File # 21-021  
SUB/VAR/TREE/HD

# Bornstedt Views Subdivision

Planning Commission  
June 27, 2022

**VARIANCE A.** Variance to Section 17.100.120(B) to allow the north side of Maple Street between Street A and Averill Parkway to exceed 400 feet.

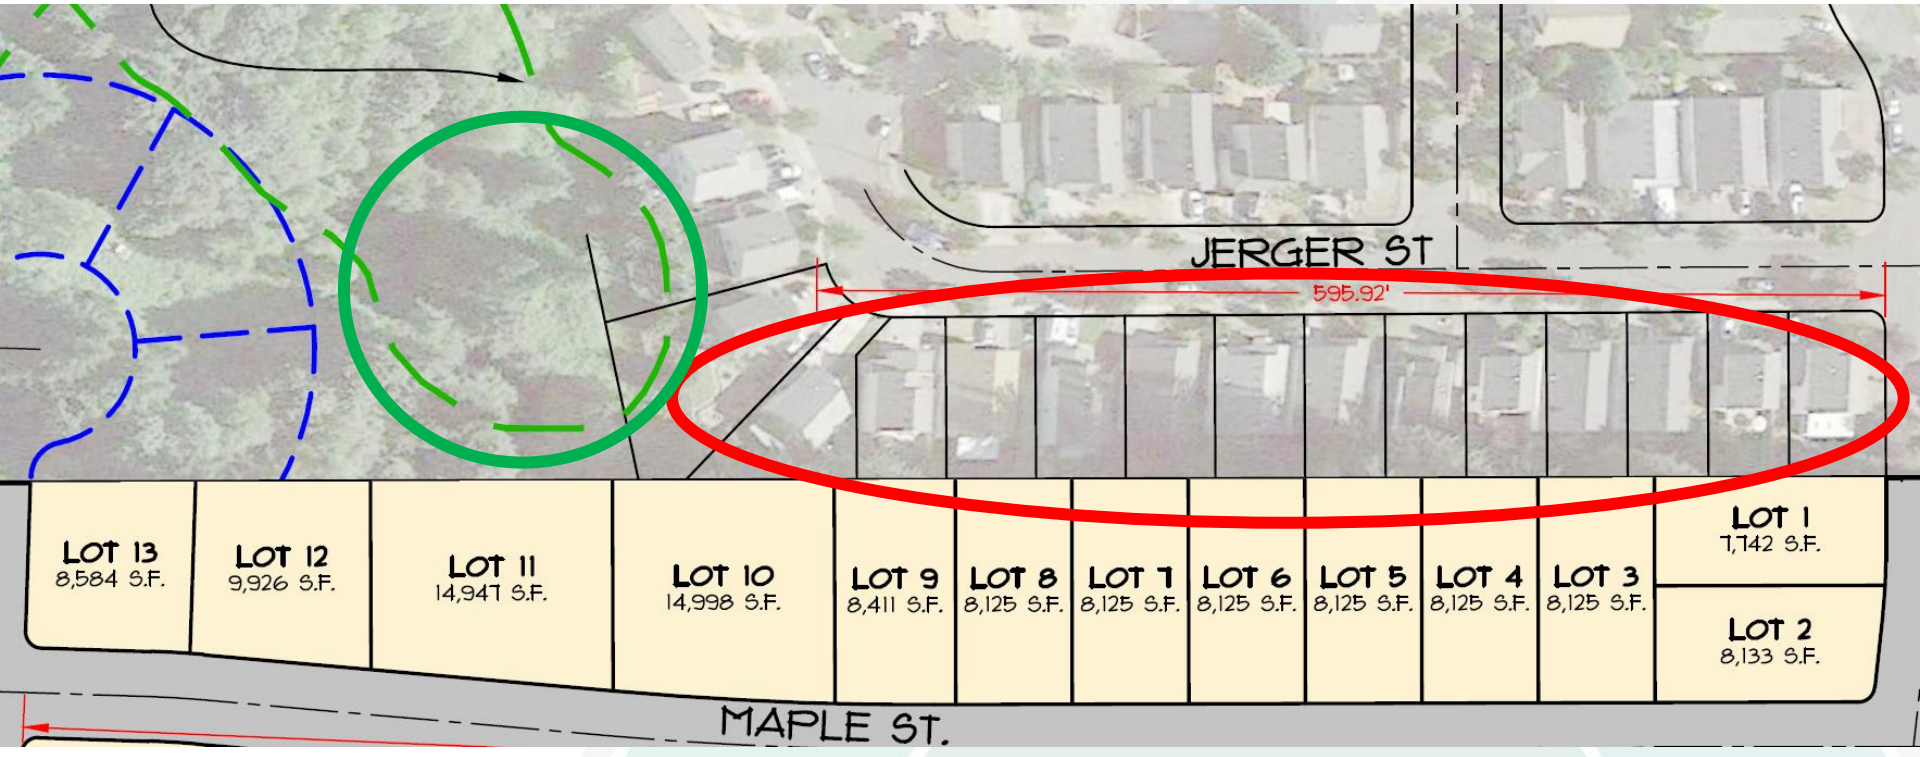
Staff recommends the Planning Commission **approve** the requested variance to Section 17.100.120(B) to allow the north side of Maple Street between Street A and Averill Parkway to exceed 400 feet.

**VARIANCE B.** Variance to Section 17.100.120(B) to allow the south side of Maple Street between Street A and Street B to exceed 400 feet.

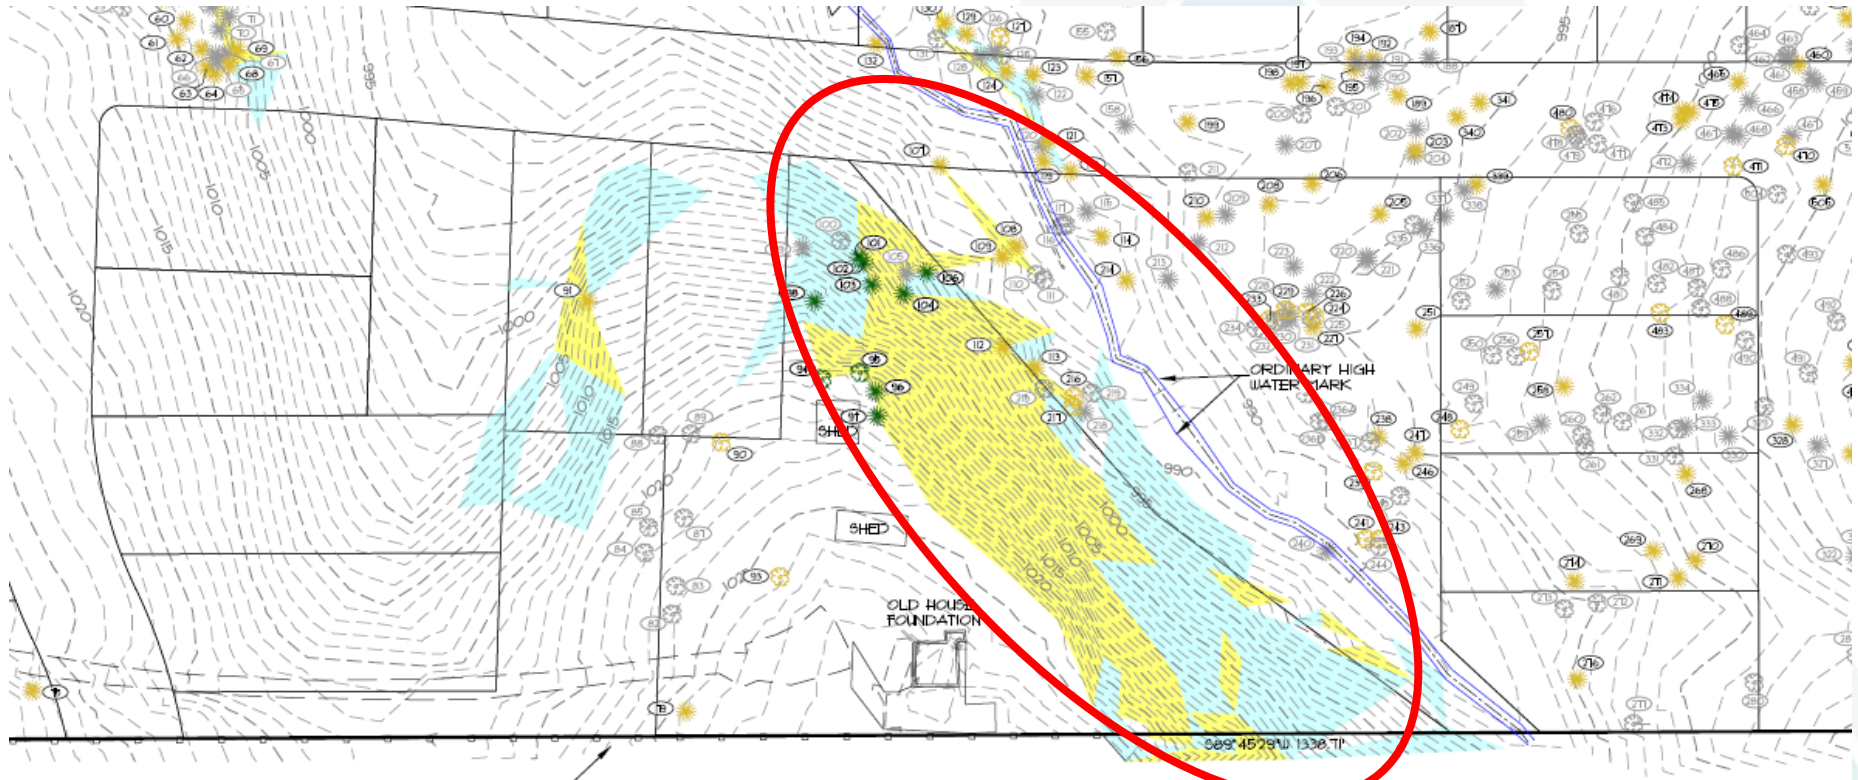
Staff recommends the Planning Commission **approve** the requested variance to Section 17.100.120(B) to allow the south side of Maple Street between Street A and Street B to exceed 400 feet.

**VARIANCE C.** Special Variance to Section 17.100.120(D) to not include a bike/ped accessway on the north side of Maple Street between Street A and Averill Parkway, which exceeds 600 feet.

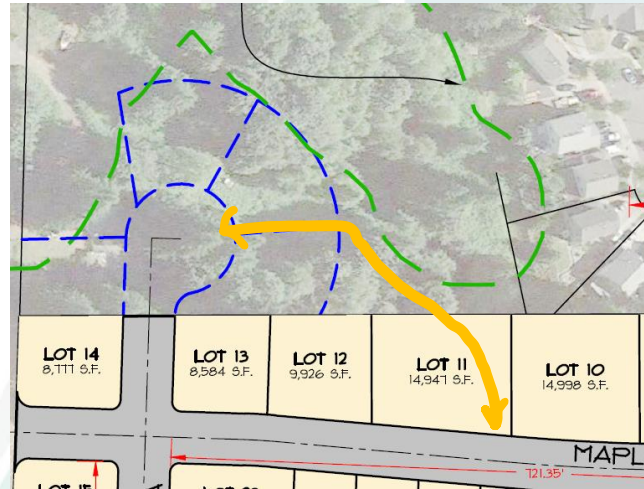
Staff recommends the Planning Commission **approve** the requested Special Variance to Section 17.100.120(D) to not include a bike/ped accessway on the north side of Maple Street between Street A and Averill Parkway, which exceeds 600 feet.

- **RECOMMENDED CONDITION:** Include a pedestrian easement and provide sufficient width for a pedestrian path through the stream, wetland, and tree protection tract between Lots 10 and 11 such that it can connect north to the cul-de-sac detailed on the future street plan upon development of the property to the northwest (Tax Lot 3600).

**VARIANCE D.** Special Variance to Section 17.100.120(D) to not include a bike/ped accessway on the south side of Maple Street between Street A and Street B, which exceeds 600 feet.

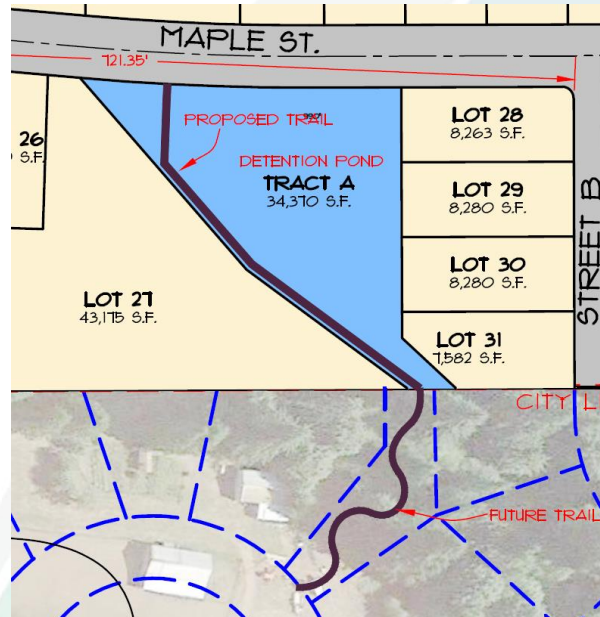
Staff recommends the Planning Commission **approve** the requested Special Variance to Section 17.100.120(D) to not include a bike/ped accessway on the south side of Maple Street between Street A and Street B, which exceeds 600 feet.

- **RECOMMENDED CONDITION:** Require a six-foot-wide soft-surface trail through Tract A as proposed.

**VARIANCE E.** Special Variance to Section 17.82.20 to allow Lots 14-18 to face the internal street network rather than Bornstedt Road.

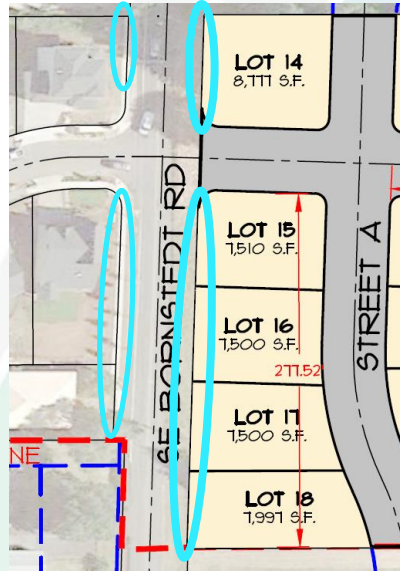
Staff recommends the Planning Commission **approve** the requested Special Variance to Section 17.82.20 to allow Lots 14-18 to face the internal street network rather than Bornstedt Road.

- **RECOMMENDED CONDITION:** Require the applicant to add additional design elements and decorative fencing along the Bornstedt Road facing sides of Lots 14-18.

**VARIANCE F.** Special Variance to allow up to an 8-foot-tall retaining wall in the front yard of Lot 27.

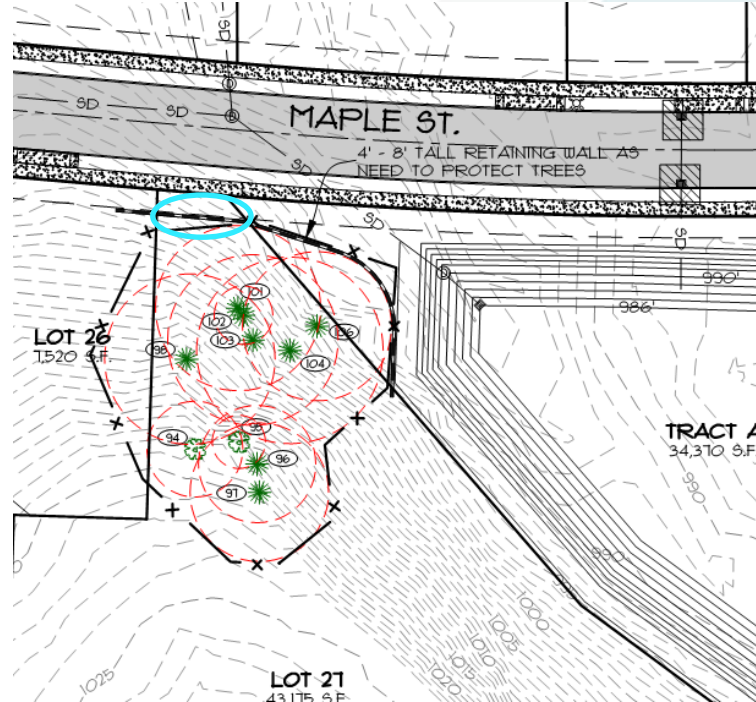
Staff recommends the Planning Commission **approve** the requested Special Variance to Section 17.74.40(A.2) to allow up to an 8-foot-tall retaining wall in the front yard of Lot 27.

# Retention Trees with CRZs

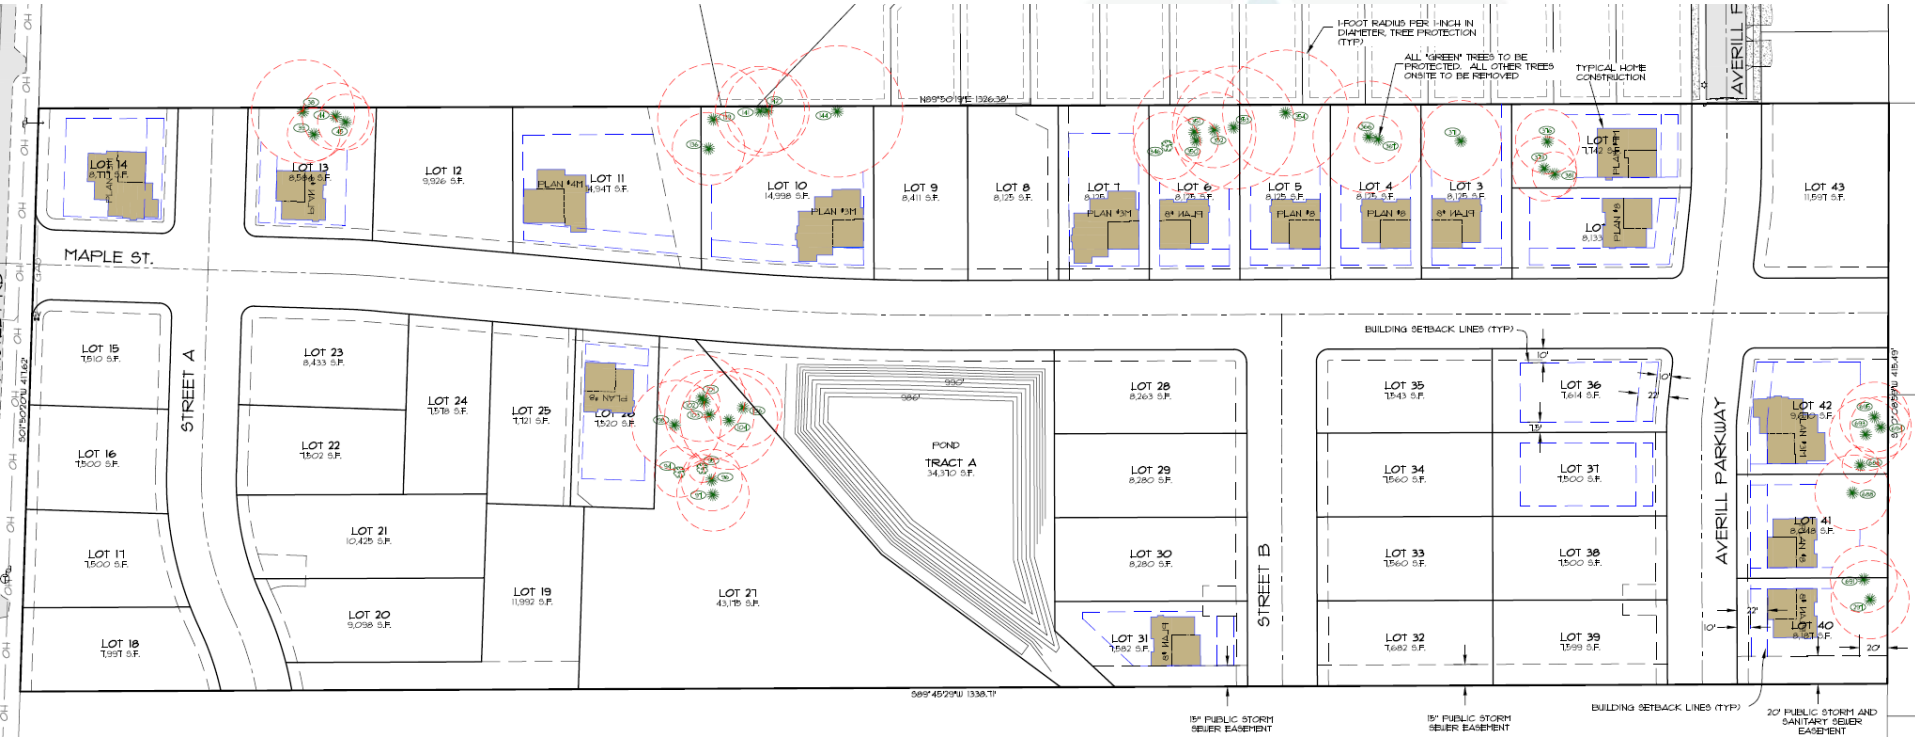
- Minimum retention requirement = 38 healthy trees, 11" DBH or greater, and likely to grow to maturity
- Applicant's proposal is to retain 38 trees
- Inventory conducted in July 2020
- Third party arborist evaluated applicant's 38 trees June 2022
  - 1 dead
  - 13 additional trees cannot be adequately protected by the root protection zone on the subject property
- Updated tree retention plan needed

# ADDITIONAL RECOMMENDATIONS

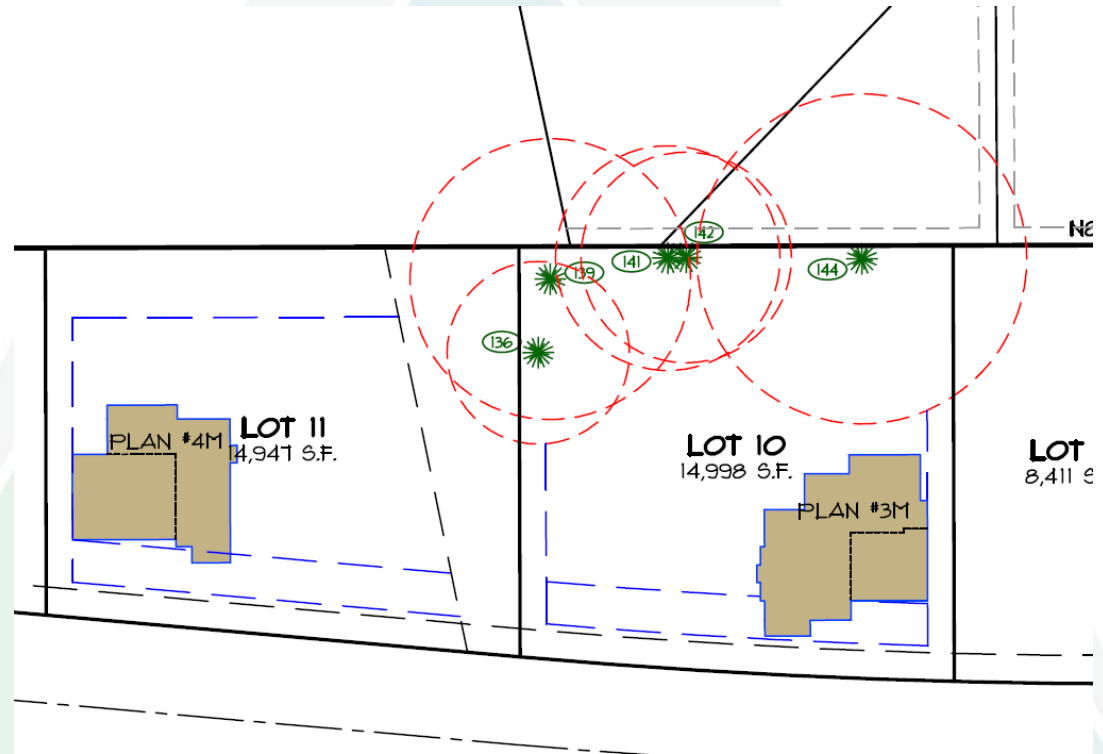
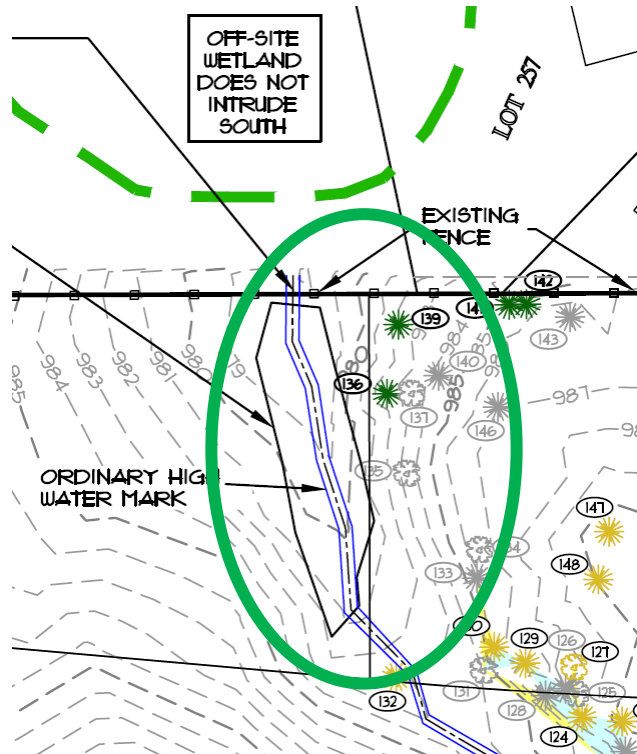
3. Joint tree protection and stream/wetland protection tract between Lots 10 and 11 either to be dedicated to the City or owned and maintained by an HOA or other private owner.
